Subject Letter of Clarification No. 2 / for Jones Plaza Canopy Replacement Construction Project for the Convention and Entertainment Facilities Department

Reference: Bid Inv. No: S50-C23391

Addendum Number B

Changes/updates to Issue for Bid Documents for the Jones Plaza Canopy Renovations Project

A-12.01

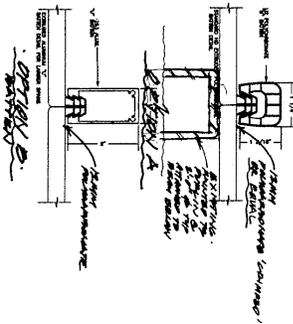
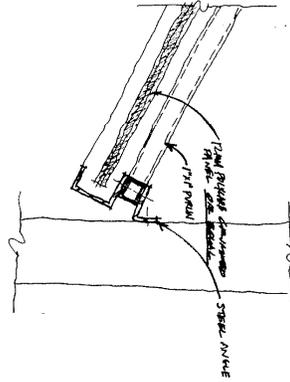
Does comply mean certified, Houston or Dade County; 110 mph vs 140 mph?
If it is to meet only City of Houston Code @110 mph, most all specified system would meet the specs, but if it is 140 mph Dade even CPI will not meet that criteria unless they use 16mm panels vs. the 12mm specified with an aluminum sub frame batten not clips.

Others have to go to 20 mm panels to meet these criteria. However if you are requiring an N.O.A. (Notice Of Approval) from Dade County only CPI has one utilizing 16 mm panels standing seam w/ batten. Extech has a system certified by Florida State at 140 mph but H batten system (Not Standing Seam). Macrolux does not manufacture a system anymore but only sells Polycarp panels. Guallina Arco Plus 626 Reverso could be designed to withstand 140 mph but is not certified (Clips). Super sky System is another one of the best and most expensive/stringent design in the industry but not listed as approved equal. Basically you can use a batten system with aluminum substructure or standing seam system with clips at about 100K difference in material plus additional labor (about 30K). Furthermore, other manufacturers have informed us those canopies are exempt from N.O.A. since they can not be tested with a cyclical envelop method.

Drawing A12.01: multi-wall polycarbonate sheets-minimum *16 mm thickness, not 12mm as shown on details.*
